FED. ROAD DIST. NO.	STATE	PROJ. NO.	FISCAL YEAR	SHEET NO.	TOTAL SHEETS
HAWAII	HAW.	I-H3-1(72)	1991	C.O. ADD. 7	521

TYPICAL ROADWAY SECTIONS
H3 KANEHOE INTERCHANGE

INTERSTATE ROUTE H-3
F.A.I. PROJ. NO. I-H3-1(72)

**TYPICAL RAMP
SECTIONS AND DETAILS**

TYPICAL RAMP
SECTIONS AND DETAILS

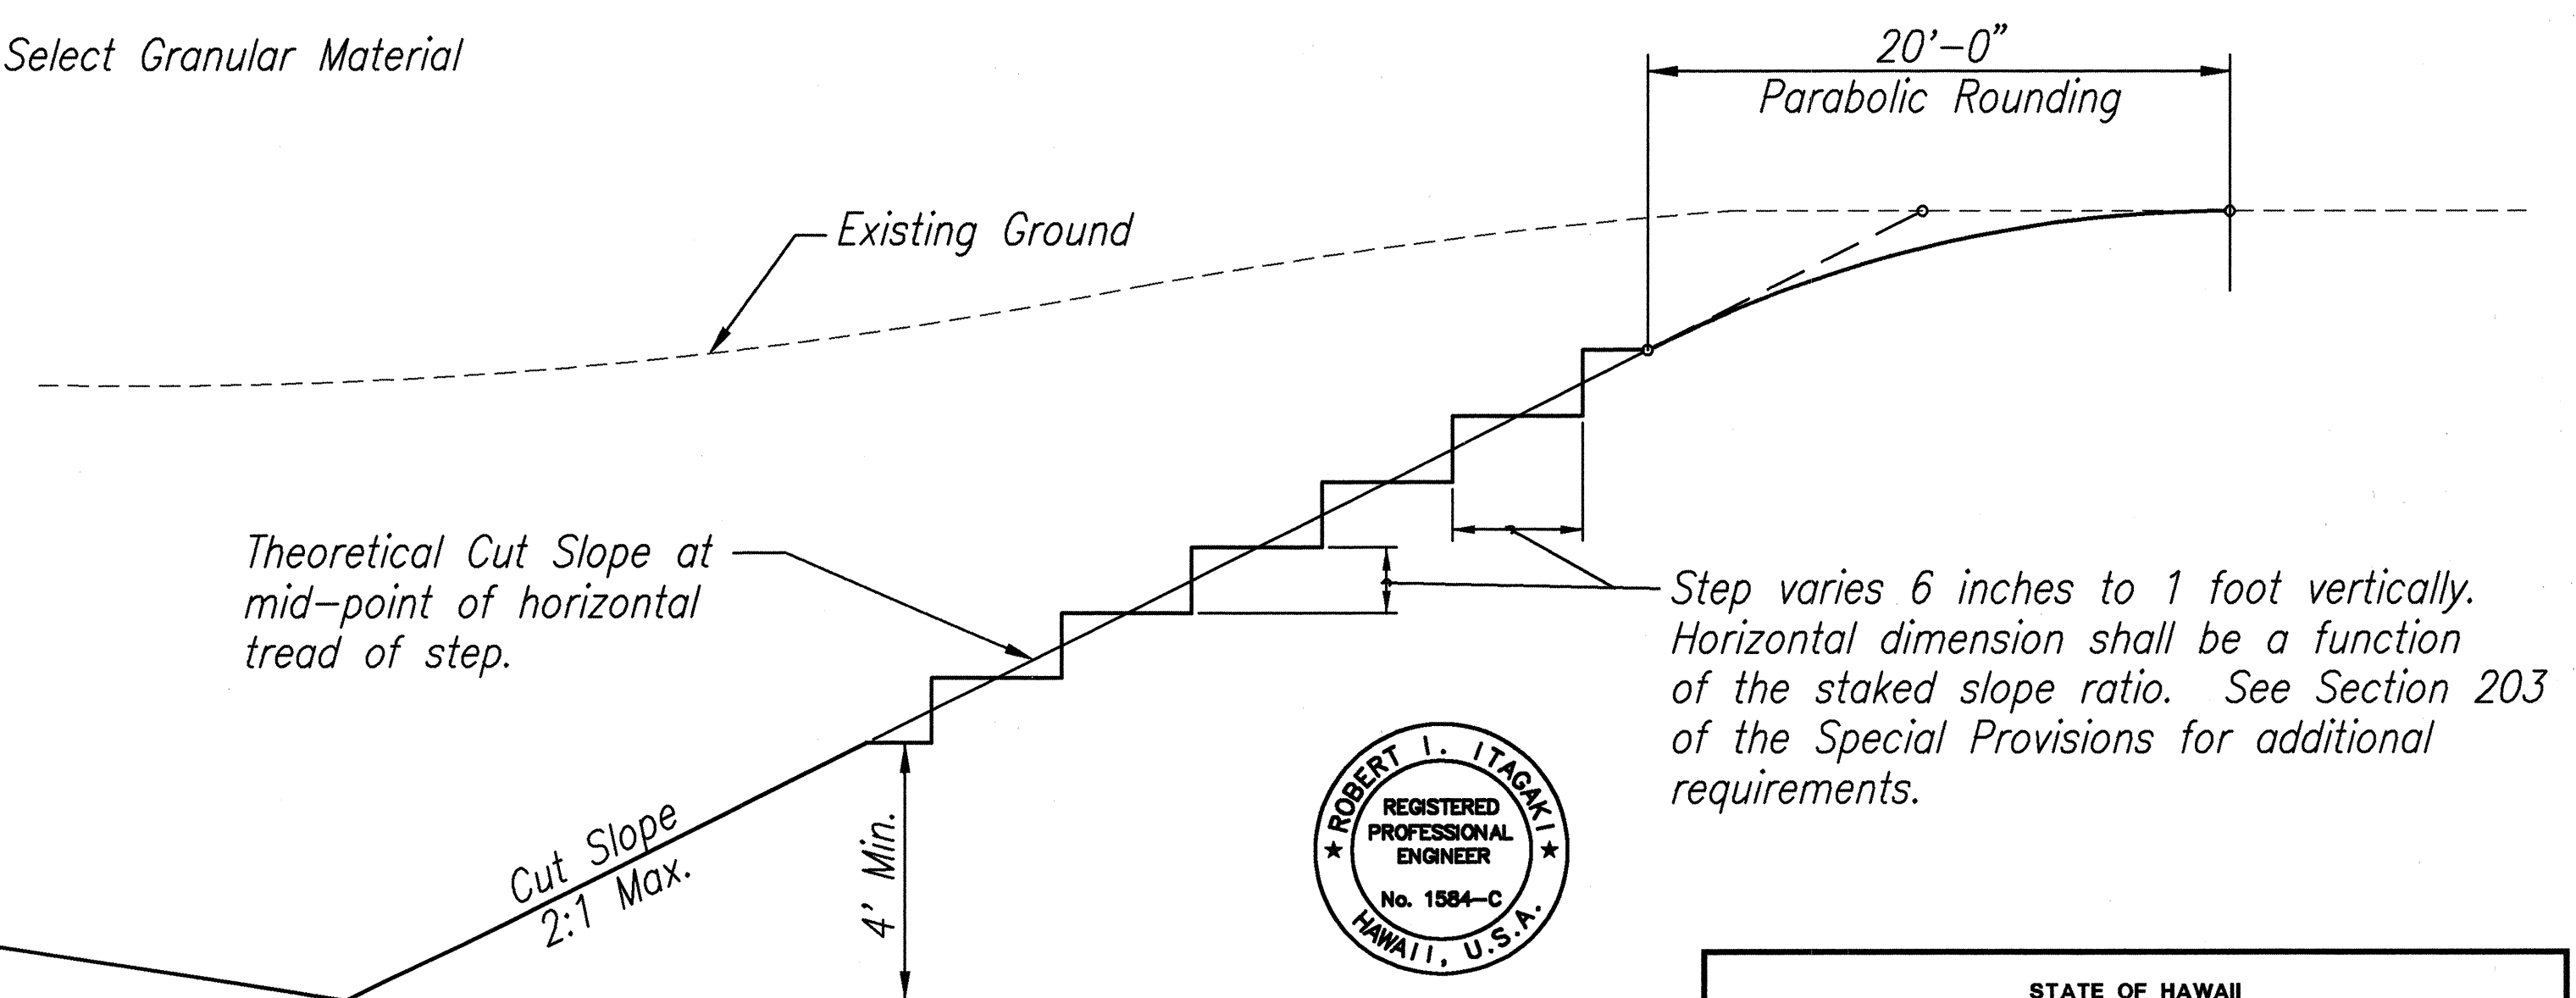
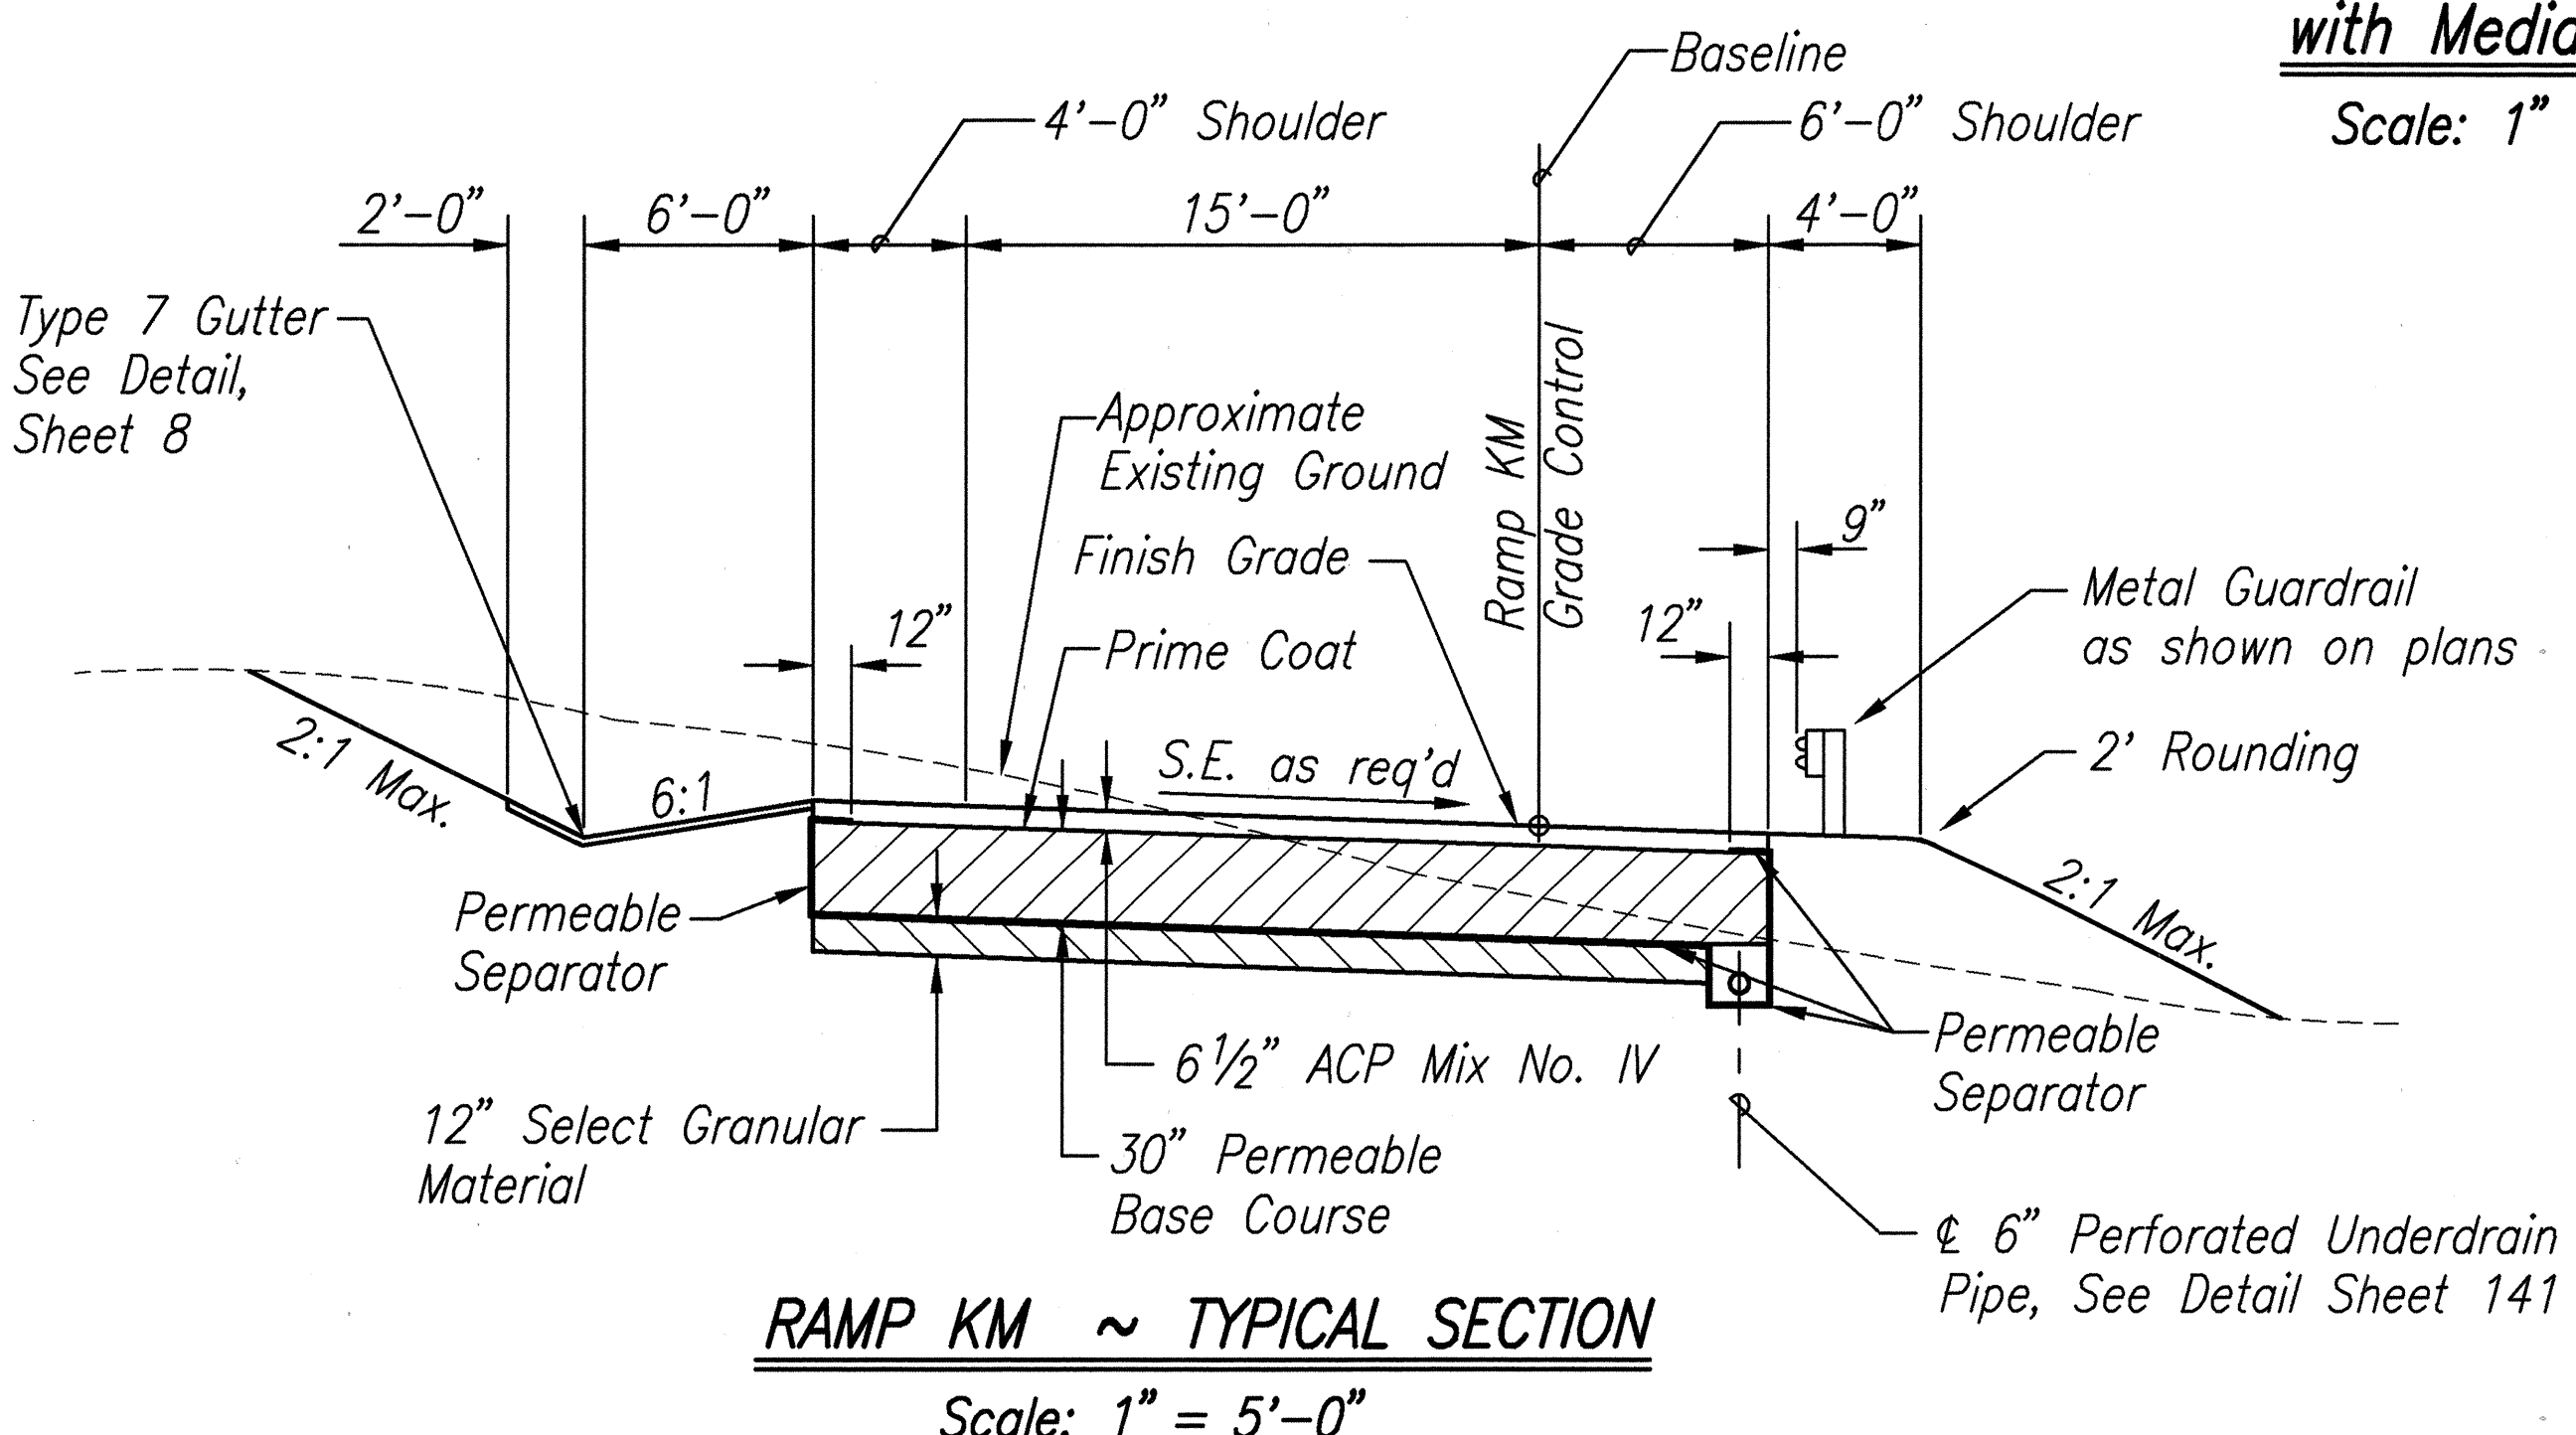
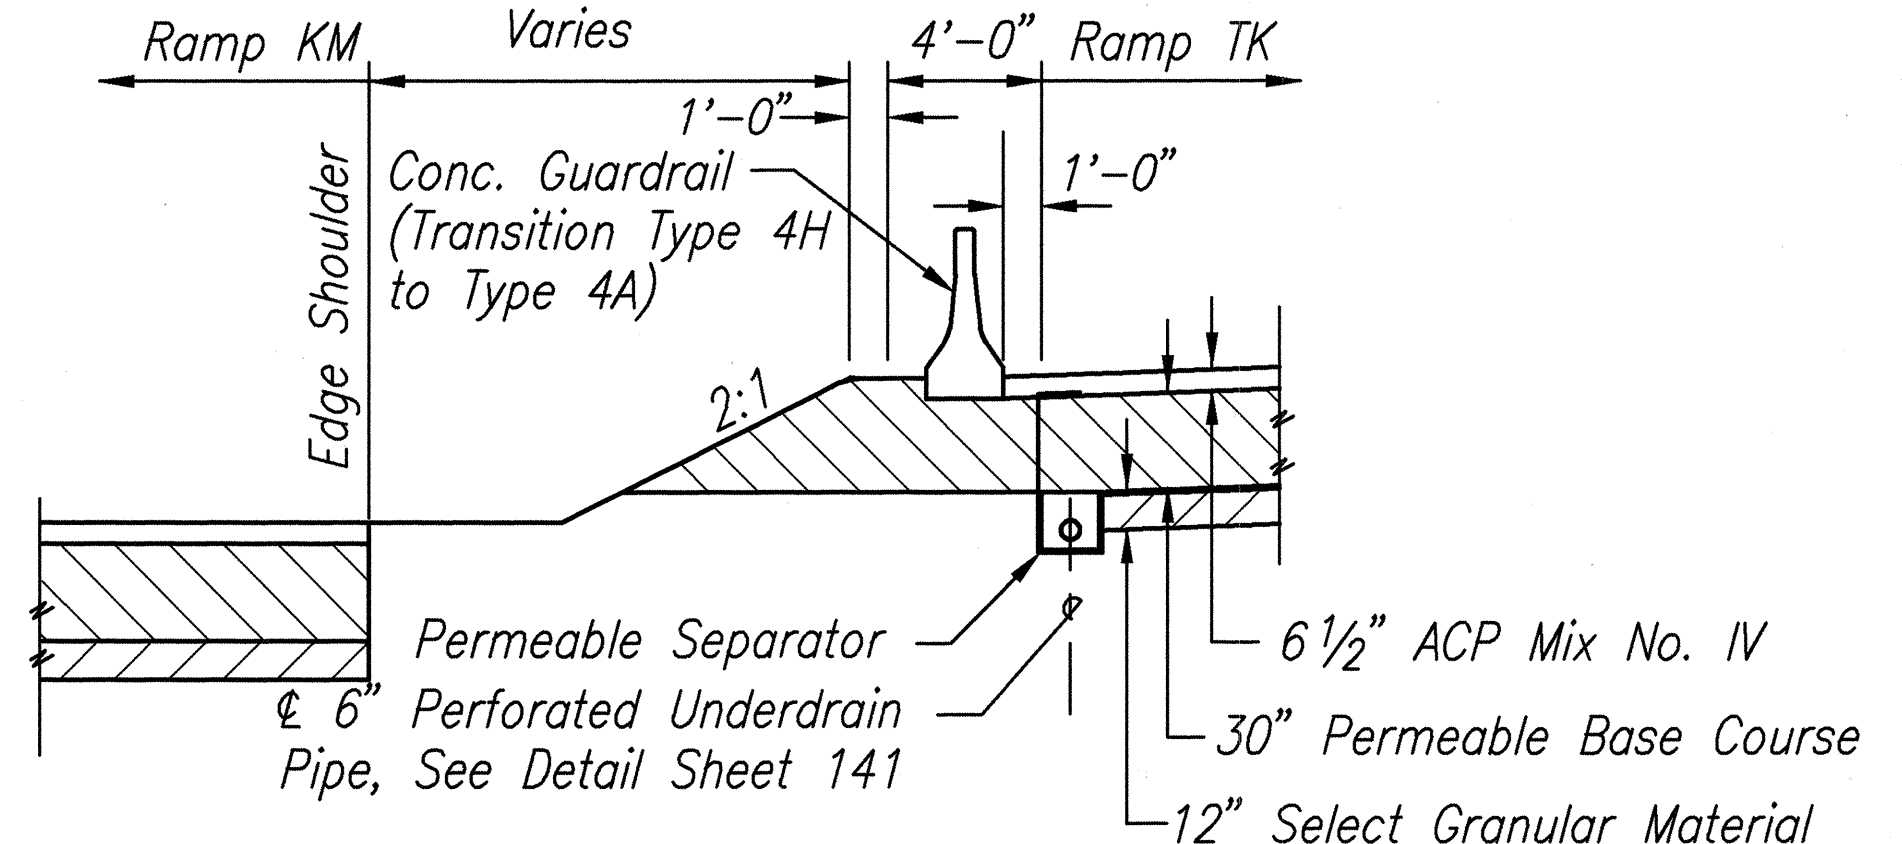
9/3/93	Revised Permeable Base Course to Select Granular Material under 4H Median Barrier @ Ramp TK & KM
3/15/93	Added Section for TK Sta. 18+50
2/17/93	Revised Ramp TK & KM typical section; Extended pavement to Median Barrier.
2/21/92	Revised Ramp TK/KM typical section from type 7 to type 7C Gutter.
1/27/92	Revised Type 2 & 2C Gutter to Type 7 & 7C Gutter, respectively.
DATE	REVISION
